AGENDA

PLANNING AND ZONING COMMISSION WORK SESSION City Hall, 385 South Goliad, Rockwall, Texas Council Chambers May 28, 2019 6:00 P.M.

PLATINUM SELF STORAGE TOWNSEND DR. ROCKWALL, TEXAS 75087 NORTH ELEVATION

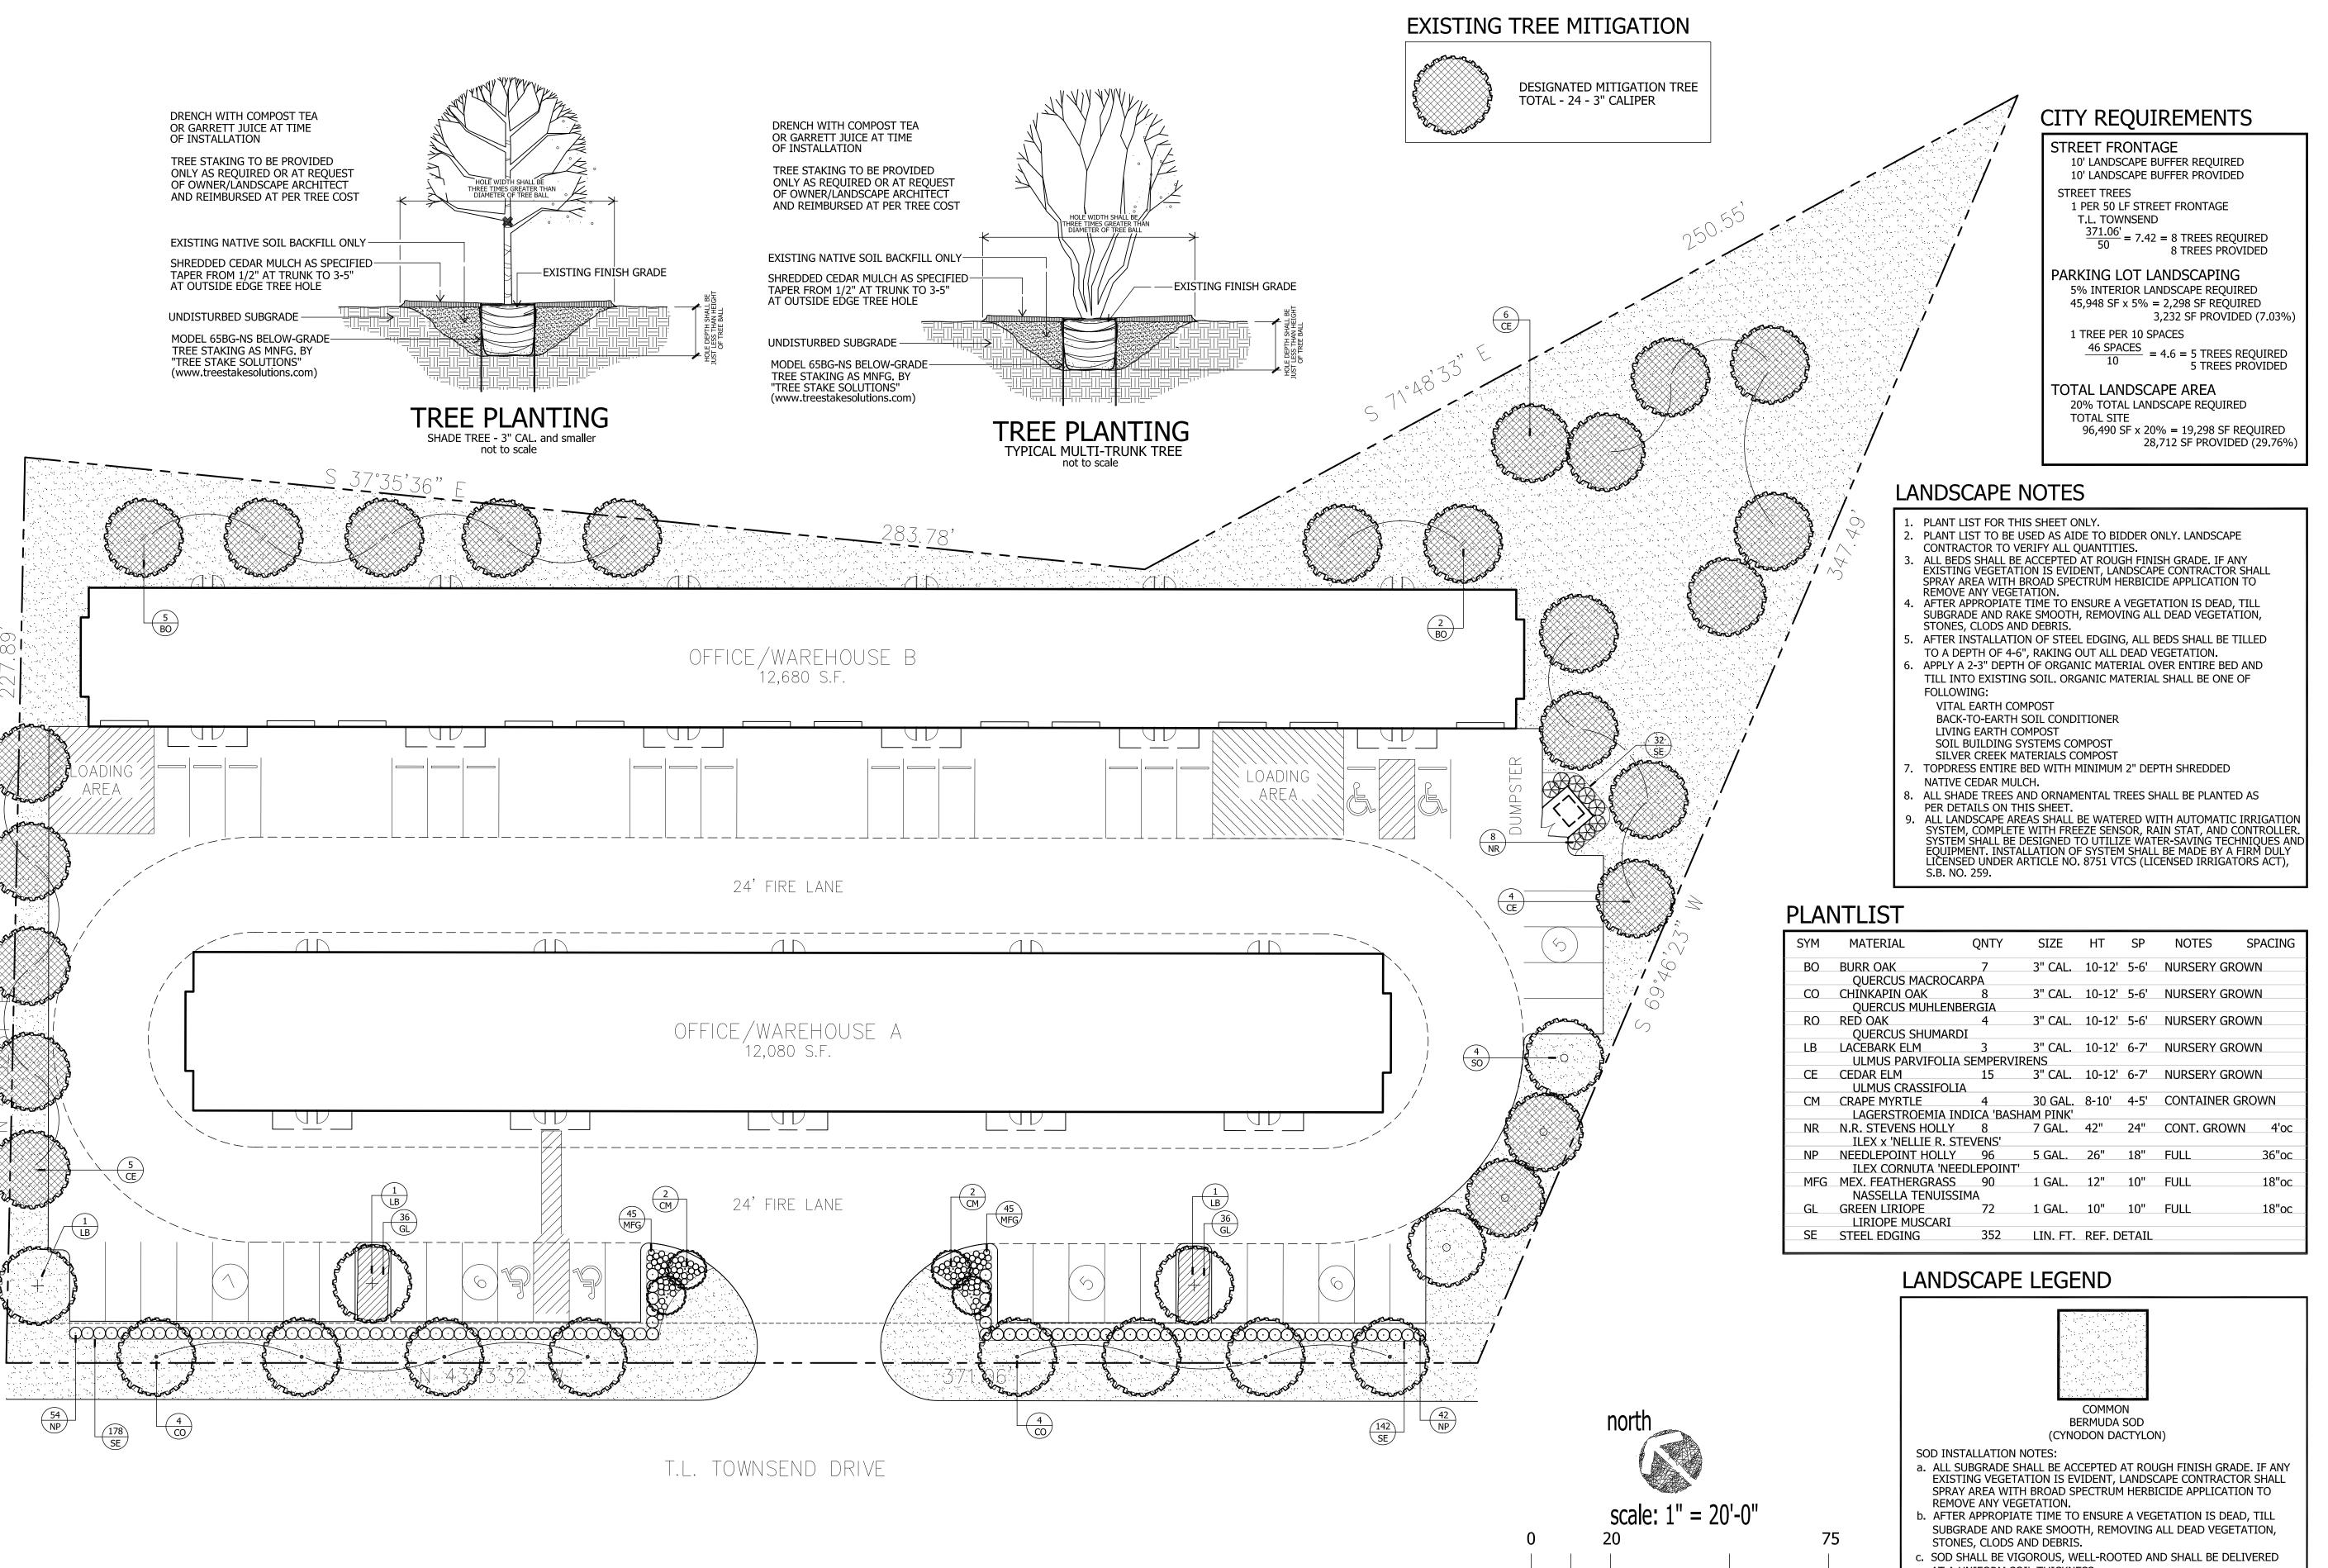
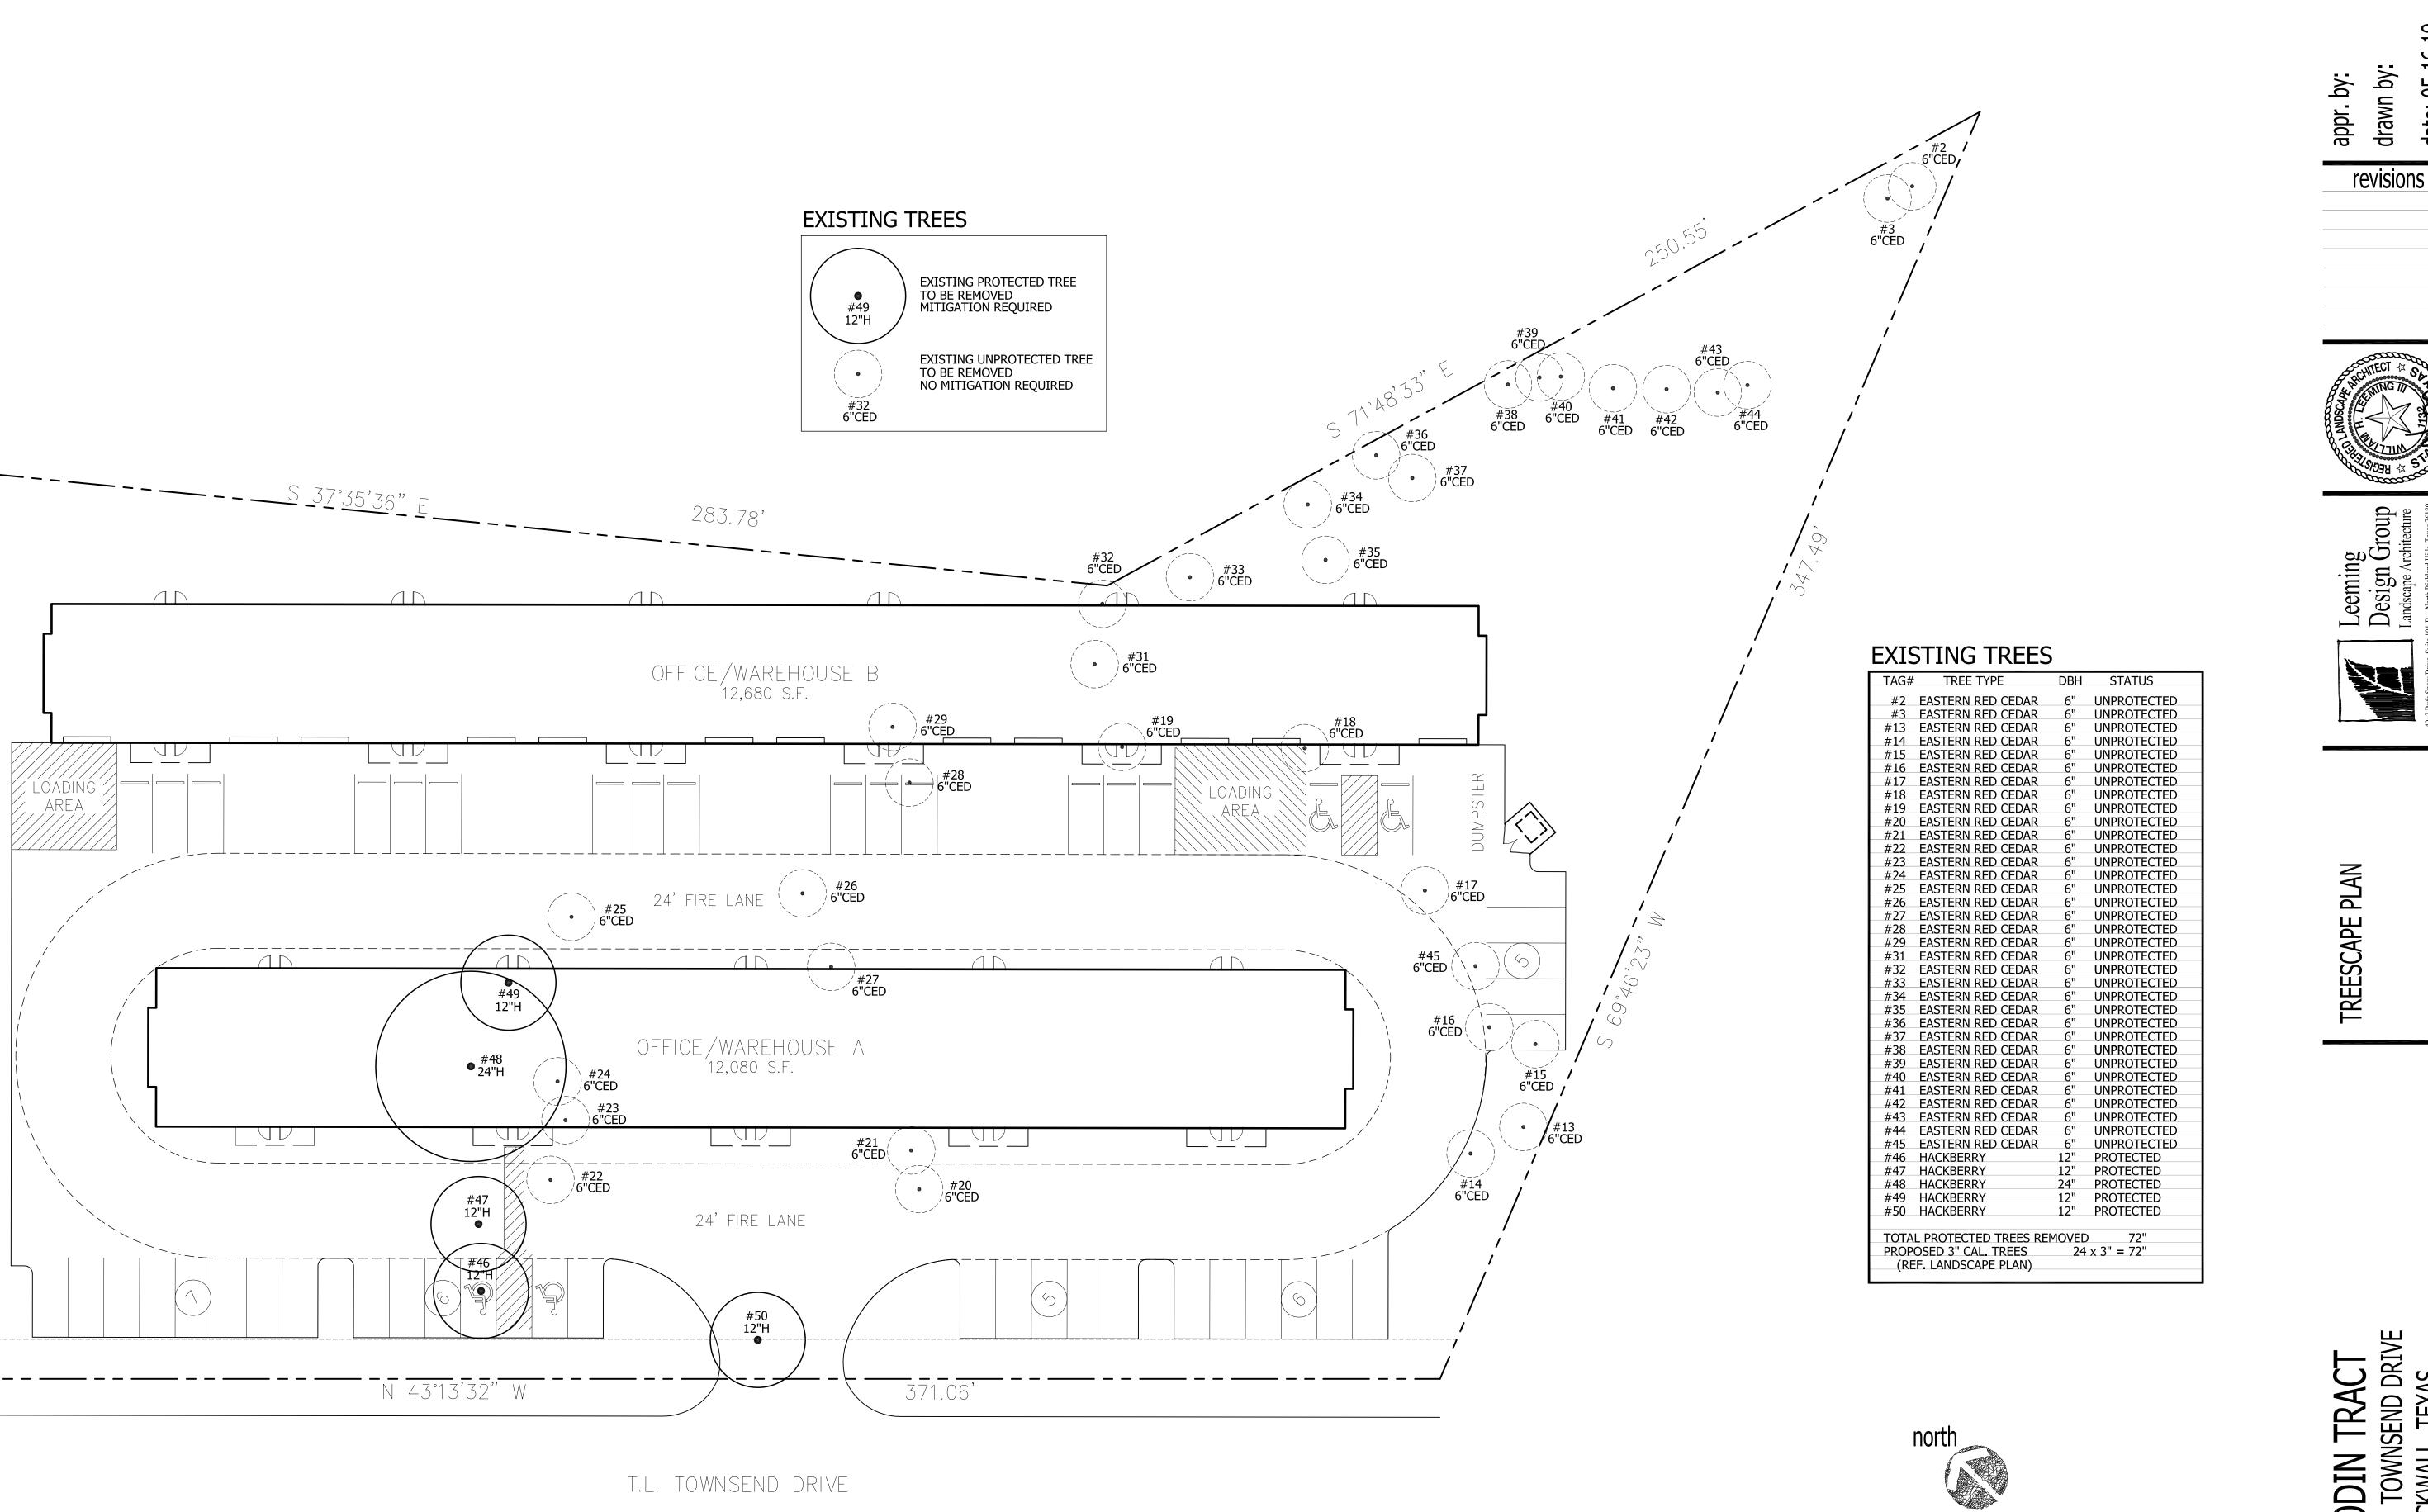
- 47. Sheet A-2—Please note that each building needs its own set of elevations.
- 48. Sheet A-2—Please indicate which elevation faces the street.
- 49. Sheet A-2—Please note that as drawn, the building elevations will need several variances: vertical and horizontal articulation, 4-sided architecture, no stone. All 4 sides of the buildings will need to be architectural finished with the same materials and elements as the front.

- 50. Sheet A-2—Please note that the min stone requirement is 20%
- 51. Sheet A-2—Please dash-in rooftop units on all elevations and show how they will be screened.

- 52. Sheet A-2—Please note that although this sheet refers to Building B, the two material percentage charts at the bottom of the page refer to Building A.

- 53. Sheet A-2—Building B, South Elevation notes the same scale as the North Elevation, however, they are not drawn to the same scale.
- 54. Sheet A-2—Building B, North Elevation appears to show a tower element projecting from the facade; however, the South Elevation does not show a projecting element.
